800GBASE-LR1 APSU Detailed Proposal Addressing comment I-314

Introduction

- This contribution provides details for implementing the APSU signaling for an 800GBASE-LR1 PHY.
- A contribution providing similar details was presented at the 22 April 2026 Clause 178B ad hoc meeting:
https://www.ieee802.org/3/dj/public/adhoc/178b/26_0422/brown_178b_01_260422.pdf
- A straw poll taken at the ad hoc meeting indicated unanimous support.
- This contribution summarizes the straw poll and provides a few additions and corrections.

Straw Poll #3 (Brown)

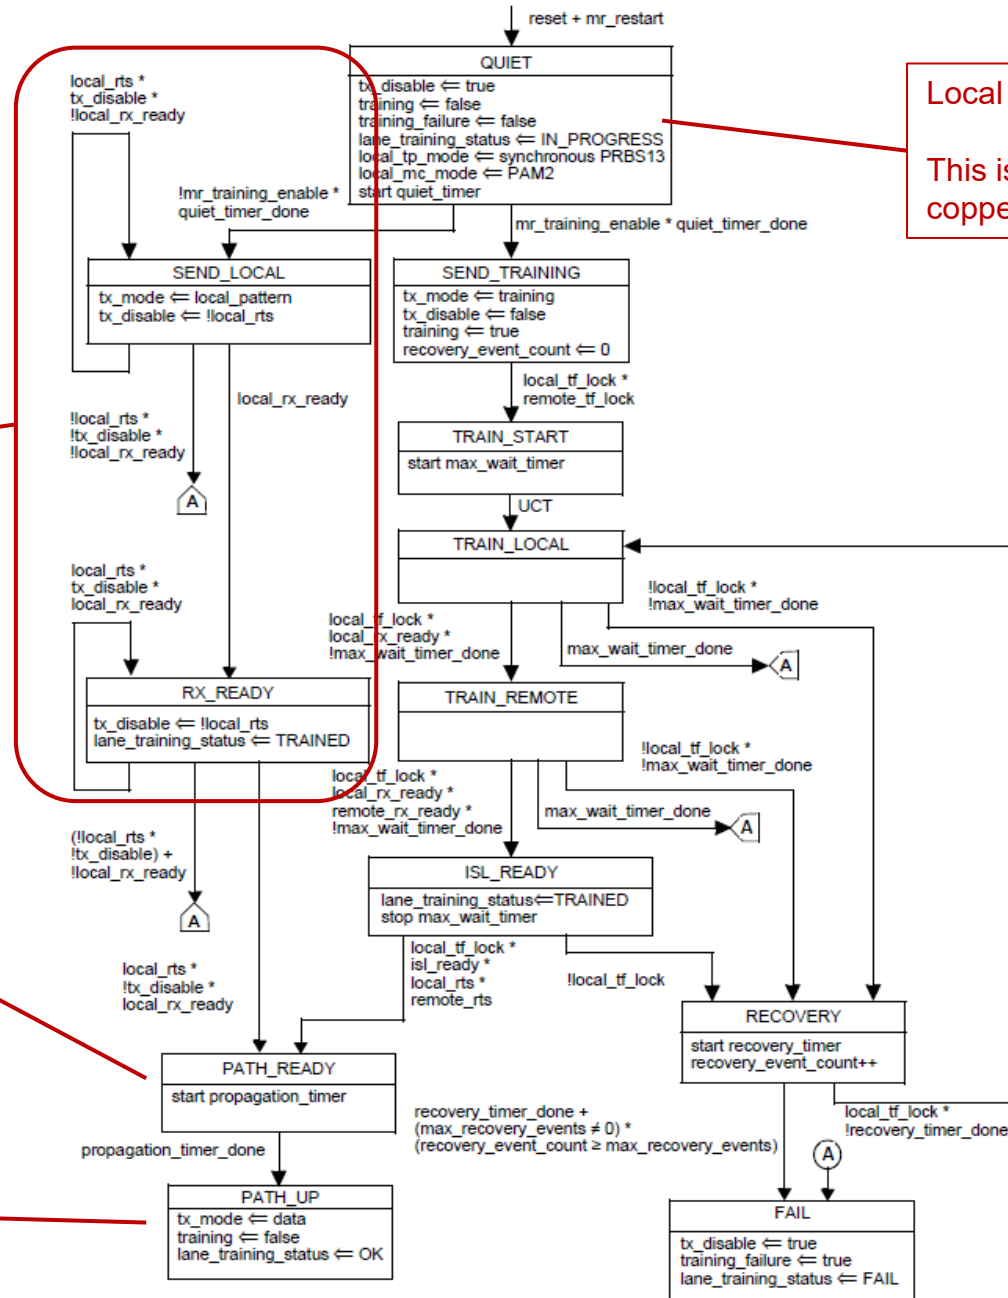
I support adopting the APSU approach proposed by brown_178b_01_260422.pdf

Results:

Yes: 16

No: 0

Based on this straw poll, amongst the attendees at the ad hoc meeting there was unanimous support for the proposed changes.

Figure 185–2—800GBASE-LR1 inter-sublayer service interfaces including 800GMII Extender

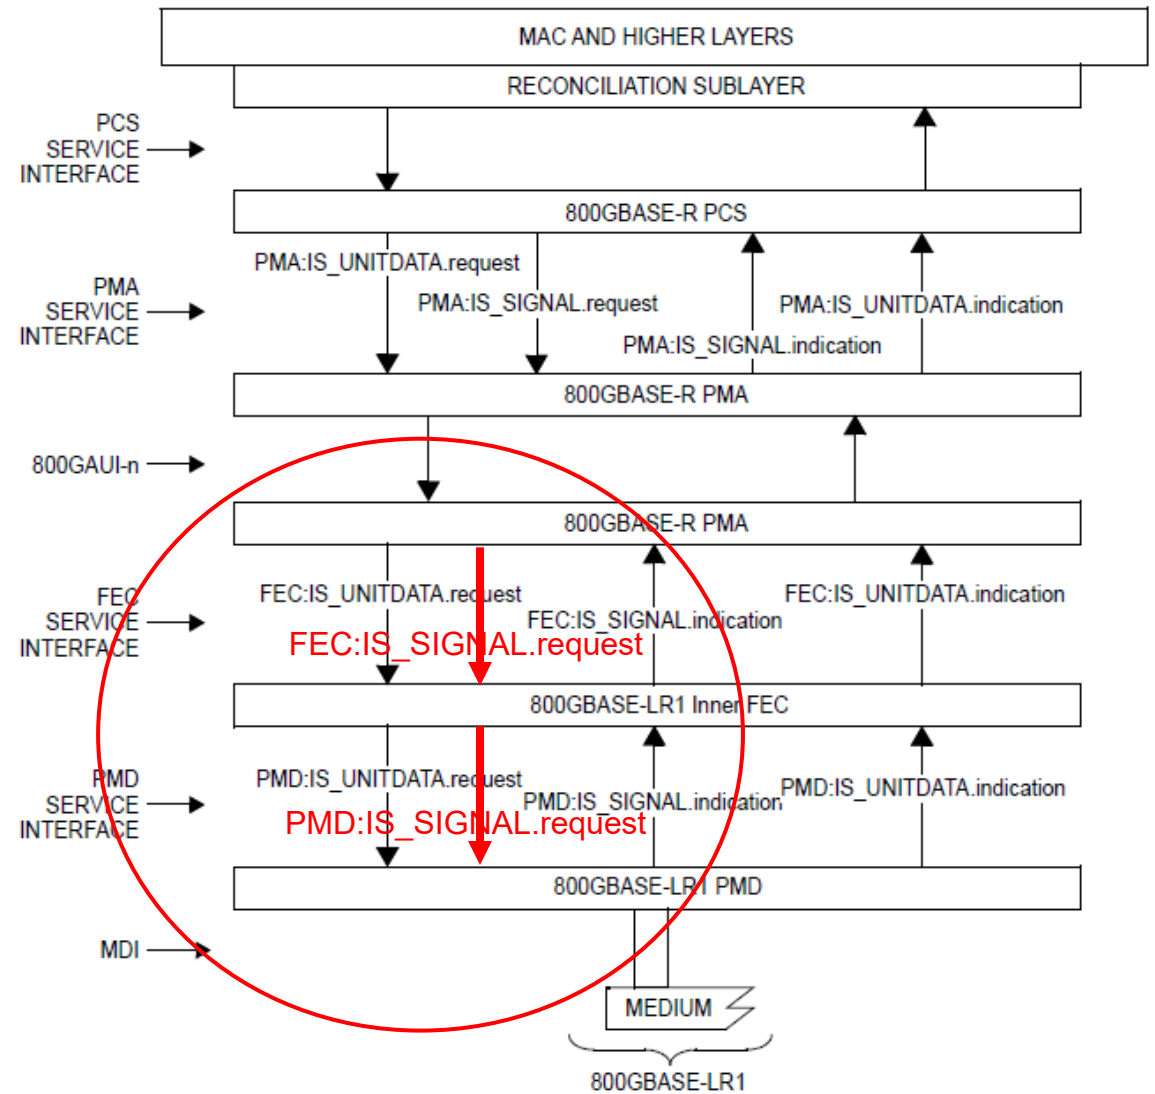
- In Clause 184 and 185, add the following SI primitives to include signal_ok in the downward direction.
- In Clause 184
 - FEC service interface (above the 800GBASE-LR1 FEC)
 - FEC:SIGNAL.request(SIGNAL_OK)
 - base definition on Clause 177 Inner FEC (177.2)
 - PMD service interface (below the 800GBASE-LR1 FEC)
 - PMD:SIGNAL.request(SIGNAL_OK)
 - base definition on Clause 177 Inner FEC (177.3)
- In Clause 185
 - PMD service interface (above the 800GBASE-LR1 PMD)
 - PMD:SIGNAL.request(SIGNAL_OK)
 - base definition on Clause 180 PMD (180.3)
